PRIMARY ROAD SYSTEM STORY COUNTY Culvert Replacement

**on US 65 culvert over Drainage Ditch
0.2 mi S of Co Rd E63/310th St in Collins**

SUBJECT: Project Concept Statement; (Draft, D0)

12-22-2025
Field Exam Notes

Field Exam Notes

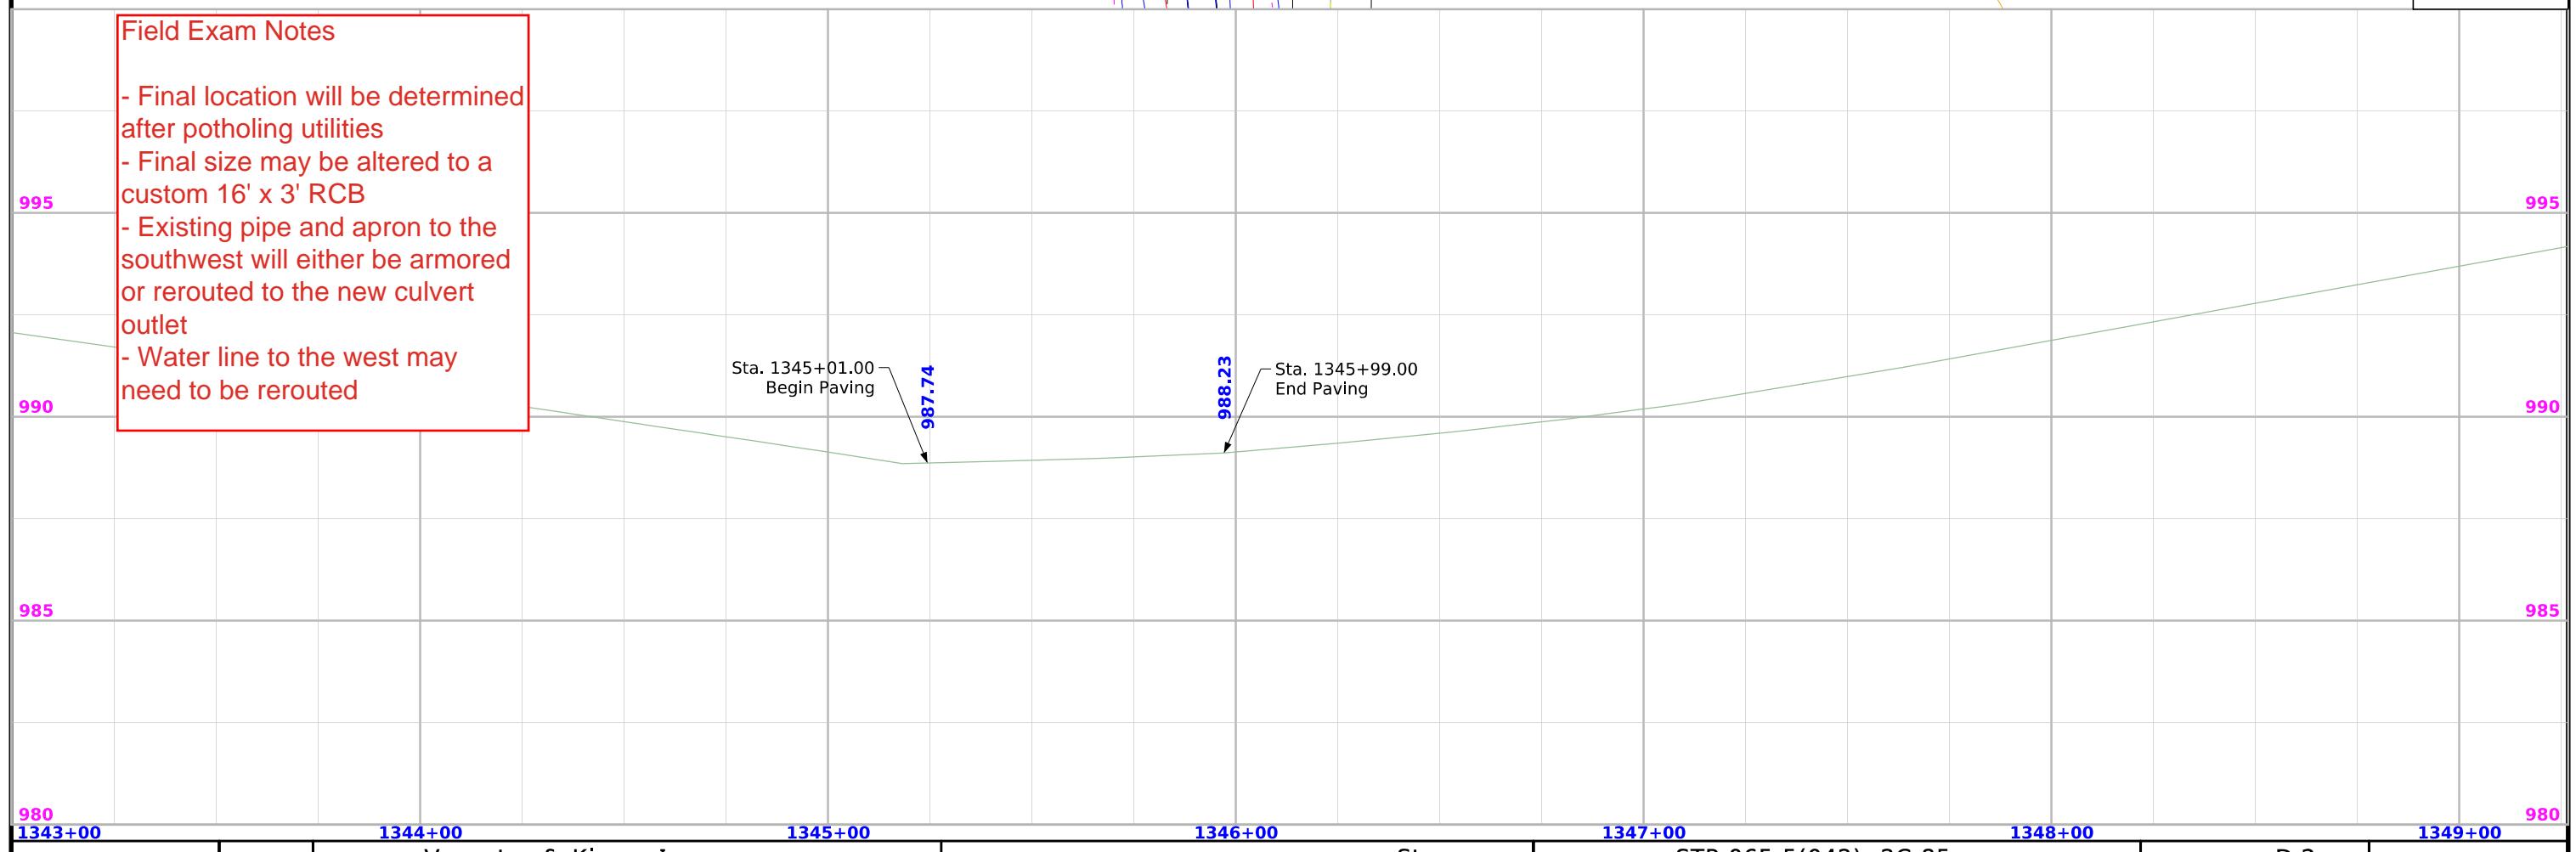
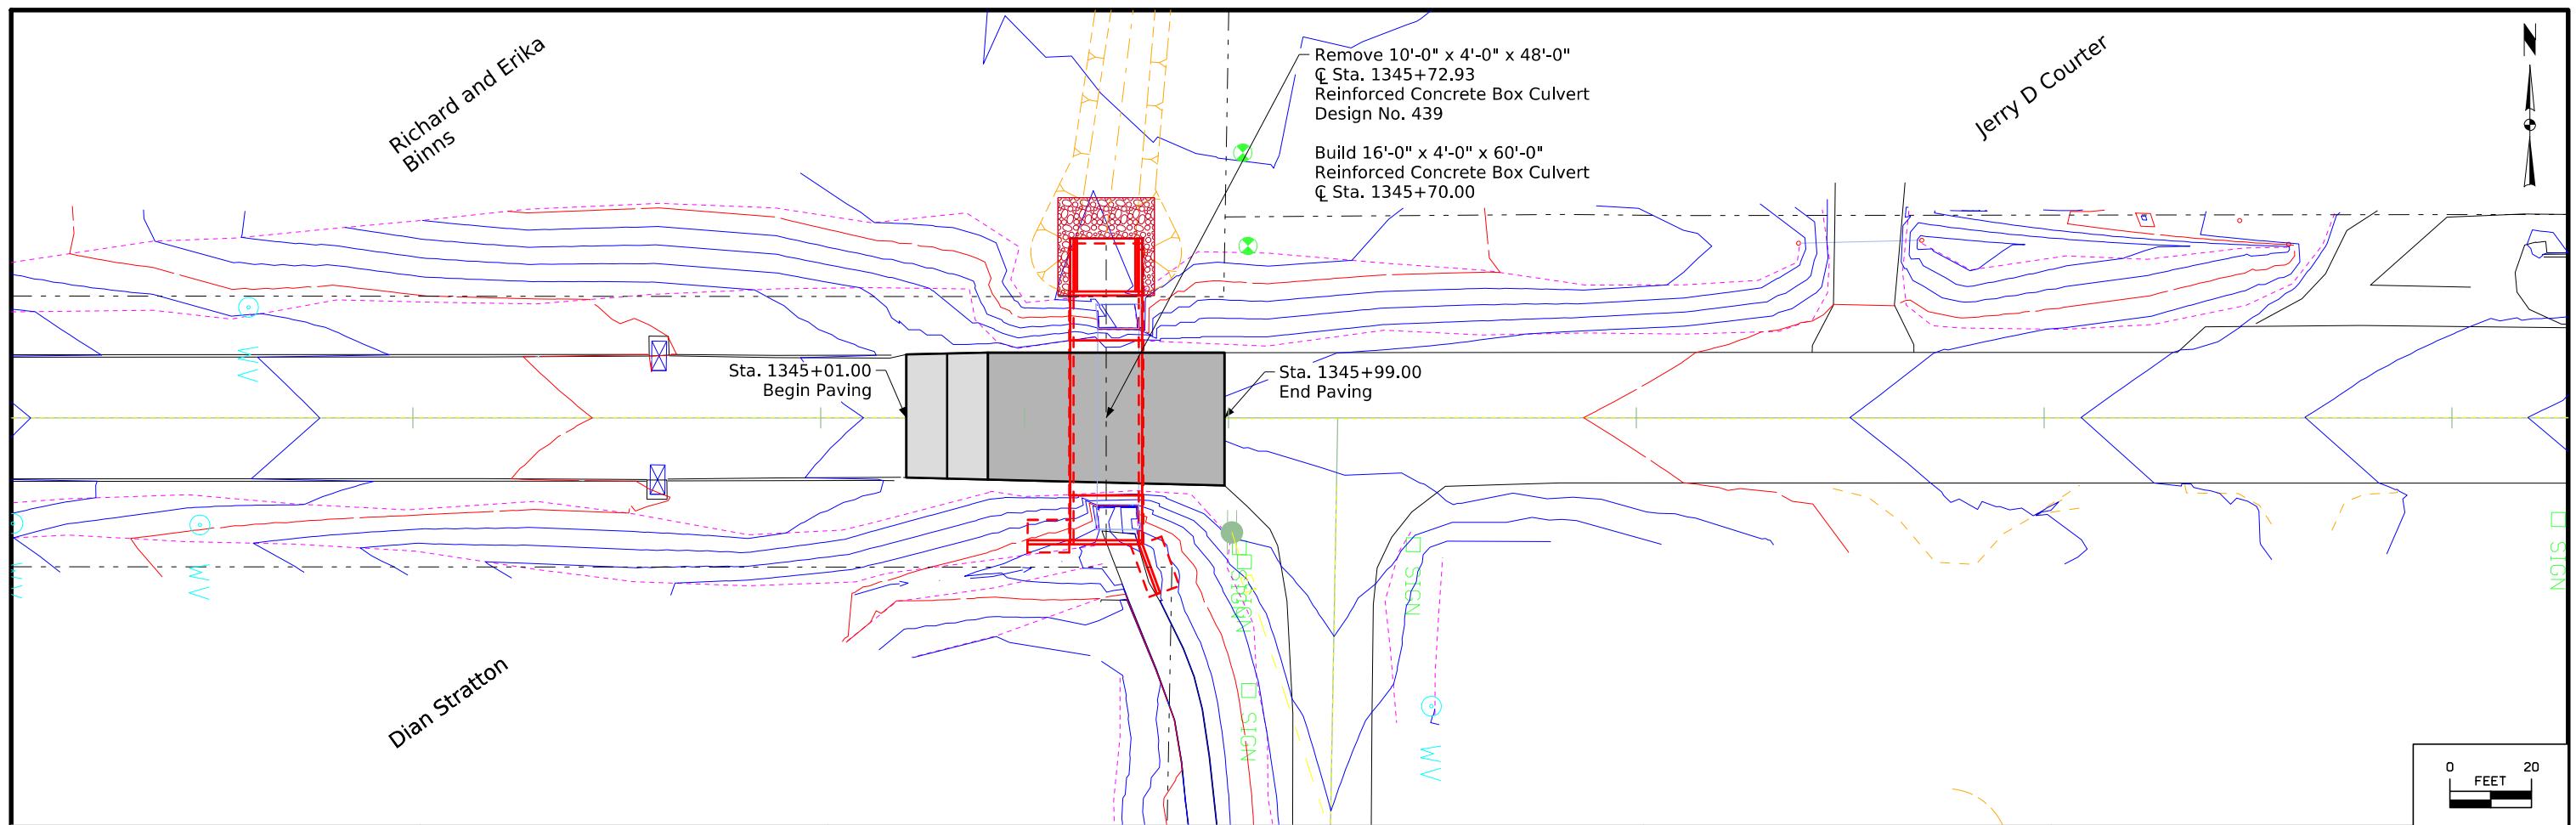
- Final location will be determined after potholing utilities
- Final size may be altered to a custom 16' x 3' RCB
- Existing pipe and apron to the southwest will either be armored or rerouted to the new culvert outlet
- Water line to the west may need to be rerouted

Situation Plan

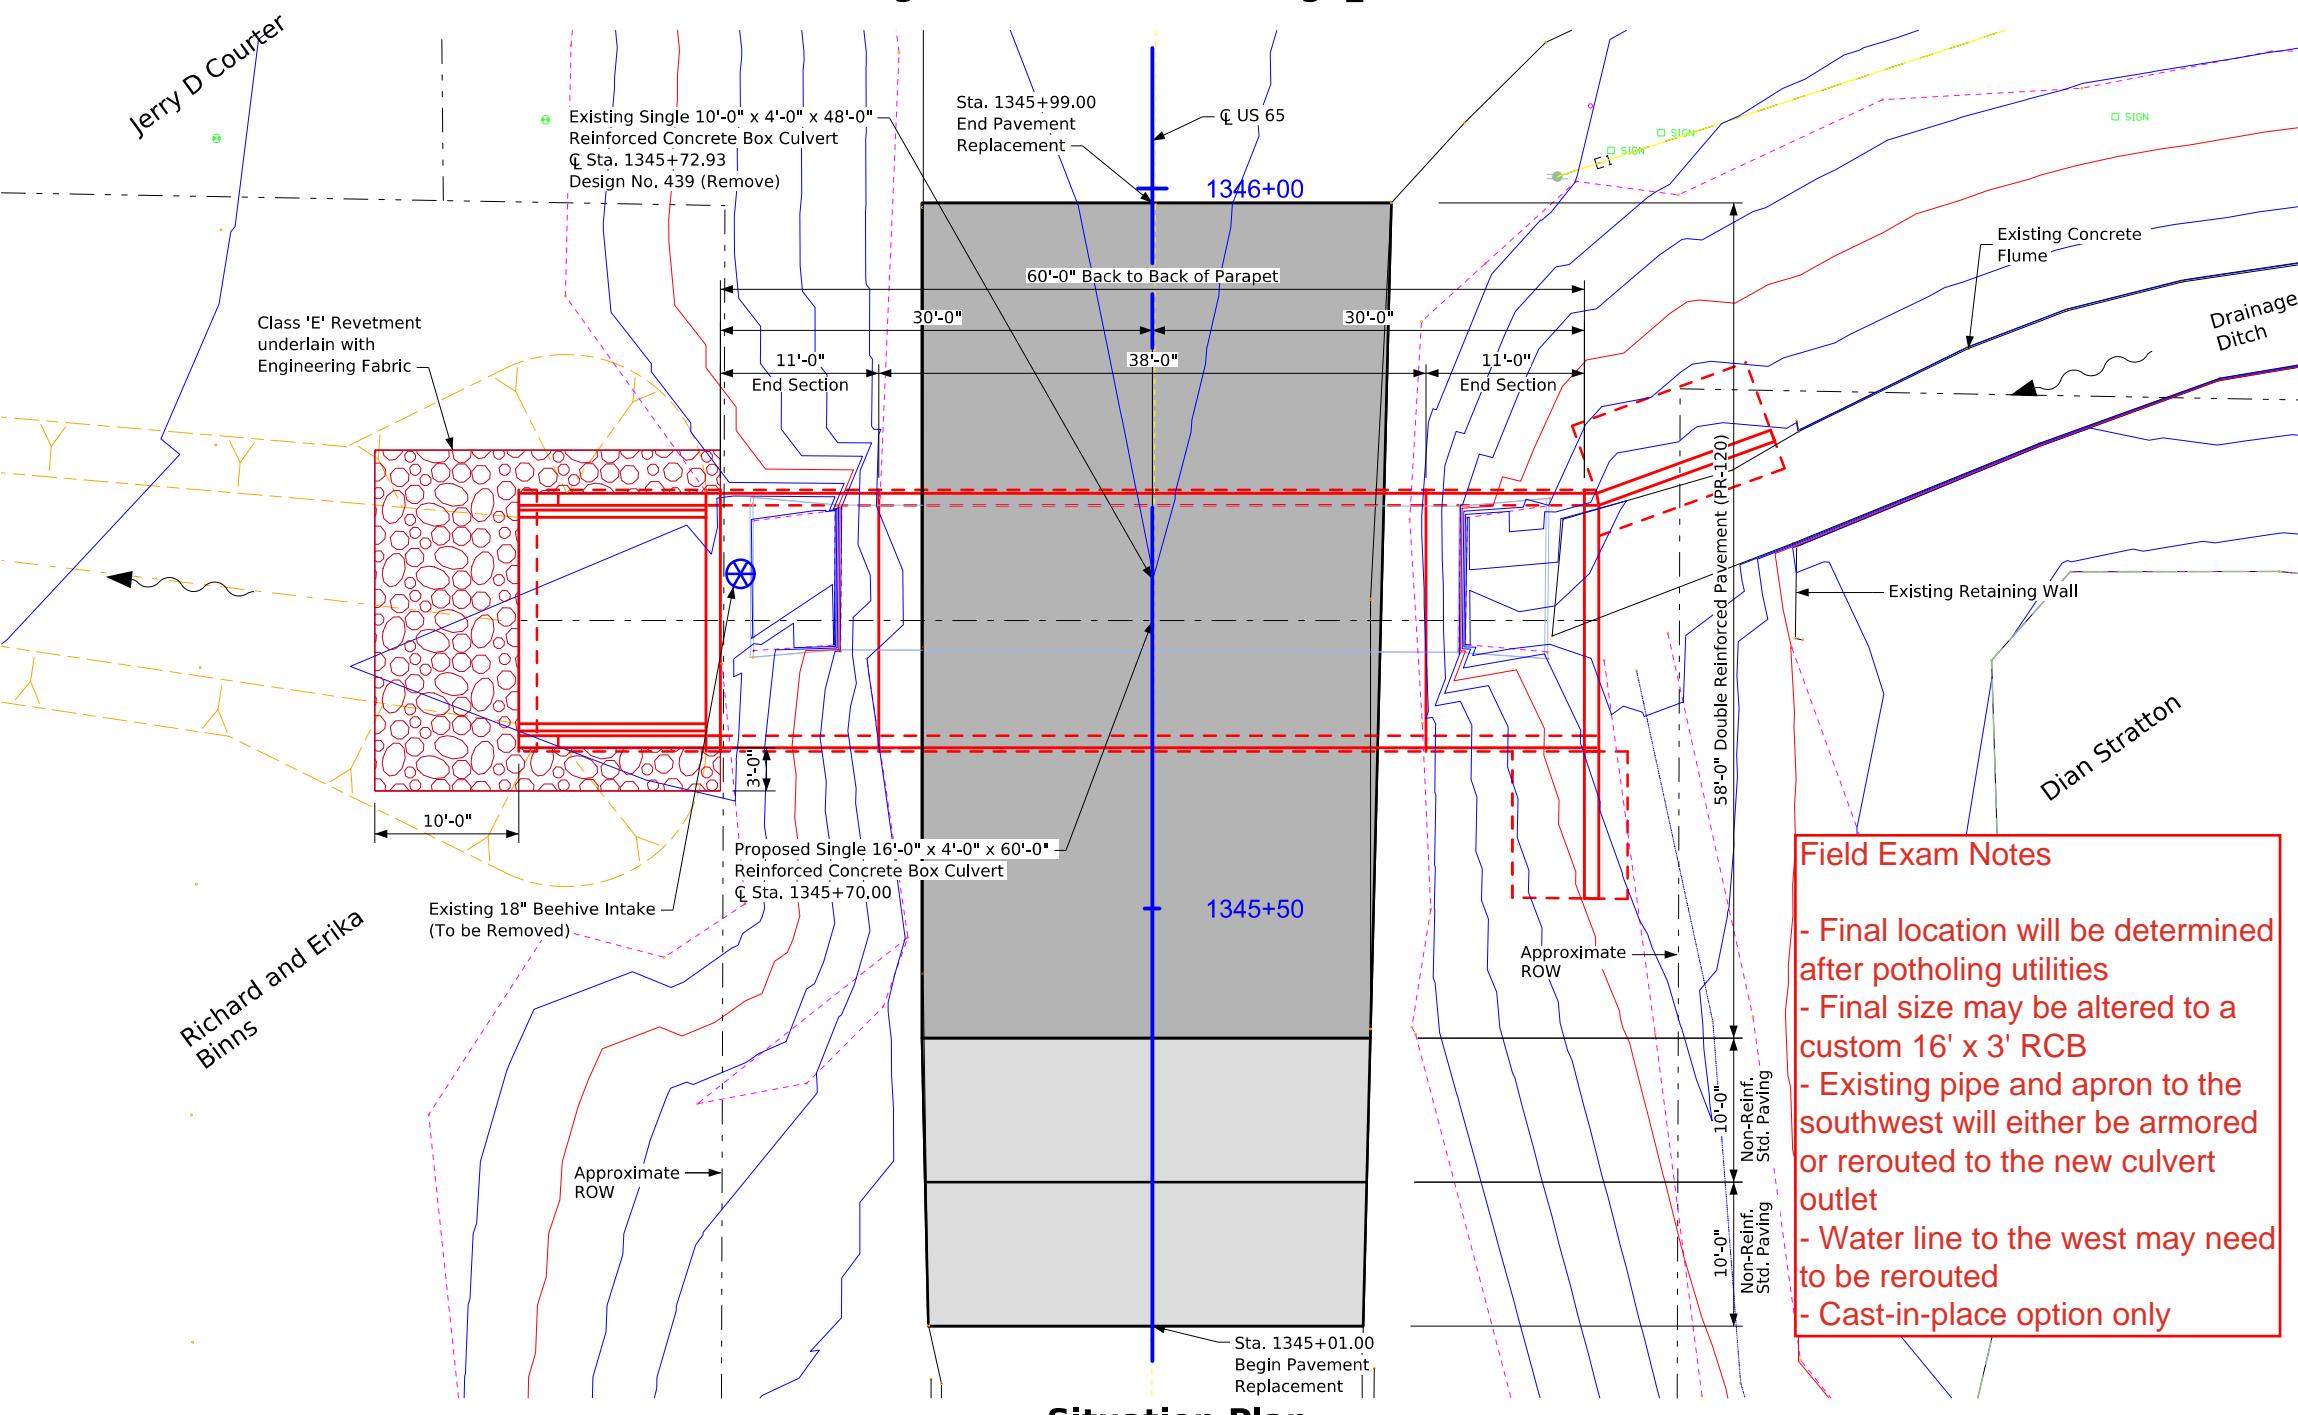
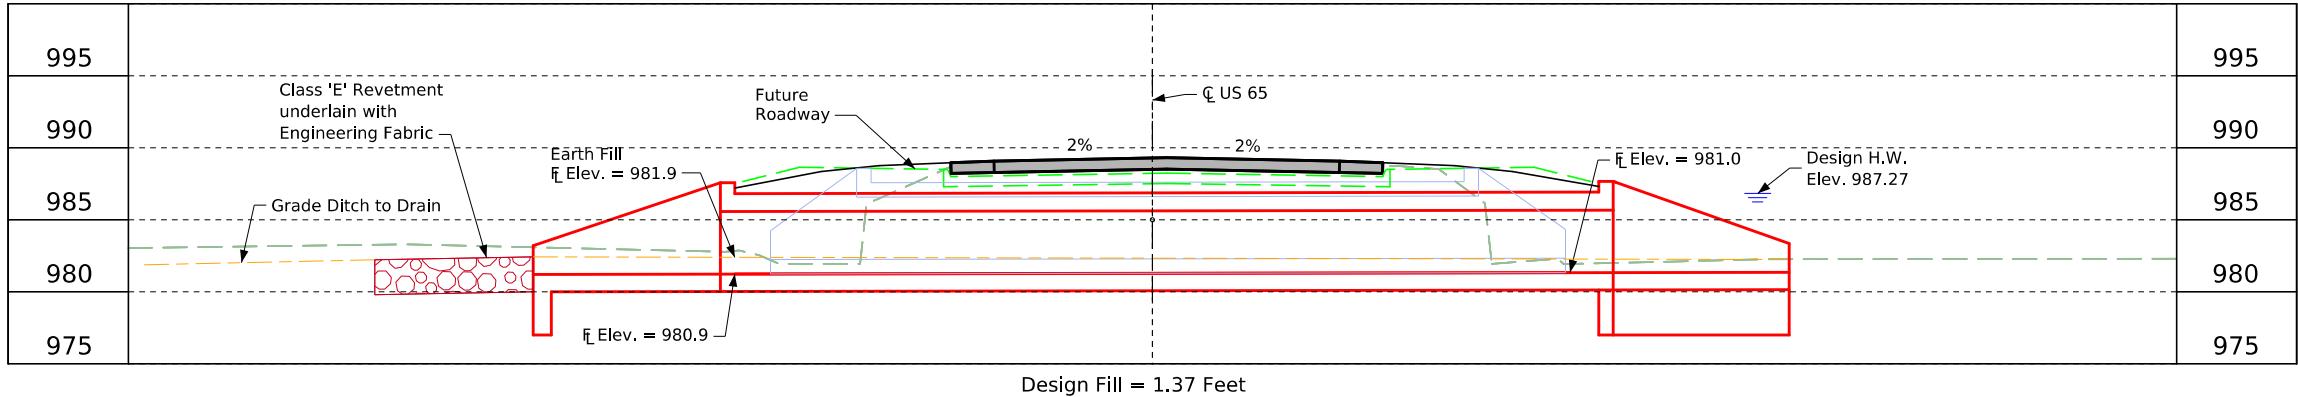
- Jim concurred on potholing for utilities to verify exact location, both horizontal and vertical. He later added that 26" tiles are usually buried deep.
- V&K recommended probable change from 16x4 to 16x3 custom RCB to limit excavation and evaluation of the curtain wall.
- V&K proposed to route the existing water line in the west depending on potholing information.

Yanxiao J. commented on apron southwest of the RCB outlet. It should be rerouted to drain at the outlet of new RCB.

- V&K to evaluate between armoring vs routing it (add a bend/manhole). It was noted that the 2013 plan proposed to construct an intake south of the culvert that was not constructed. Jim E. noted that it is not ideal to project it to the RCB wall.
